PG&E Letter DIL-03-015

Docket No. 72-26
Diablo Canyon Independent Spent Fuel Storage Installation
Response to NRC Request for Additional Information Regarding Cask Transporter
Lateral Restraints for the Diablo Canyon ISFSI (TAC No. L23399)

**Mark-up Draft
 Diablo Canyon ISFSI SAR Amendment 2
 Affected Pages**

Cask Transporter Lateral Restraint Load Reduction Study

Figure 1: Plan View of Seismic Restraints for Transporter on top of CTF

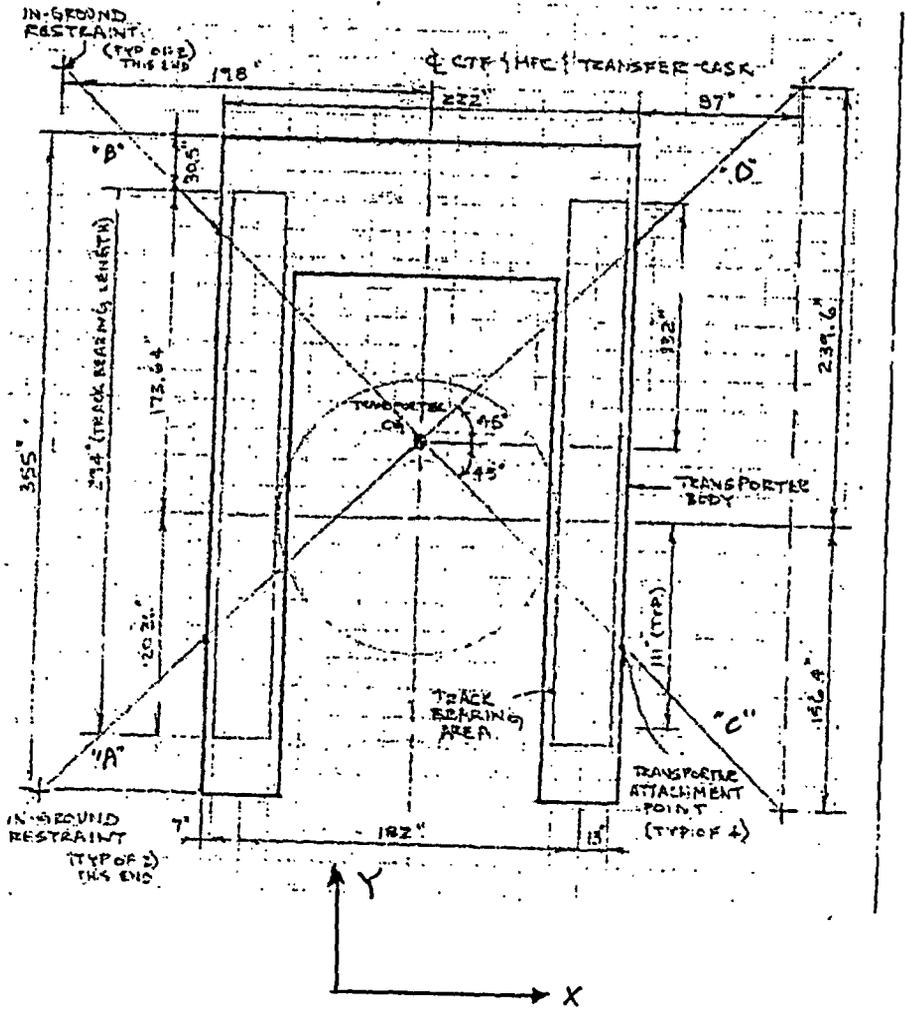
Ignoring friction resistance for now, and referring to Figure 1 attached, the upper bound force (F_{UB}) in 2 restraints marked as "A" and "B" as a result of X component of earthquake is:

The same force is developed for the Y earthquake in restraints "A" and "C" (see attached Figure 1), however the two peaks do not occur simultaneously, thus using the 100 percent–40 percent–40 percent combination rule, the peak force in any one restraint as a result of both X and Y components of earthquakes are as follows:

The above force range is calculated assuming tension-only cables are used. If struts are used which can take the load in compression as well as tension, the values of the peak seismic load in each strut would be one-half of the value calculated above, since all 4 struts will be engaged. Therefore, if struts are used, each strut will be subject to the following load:
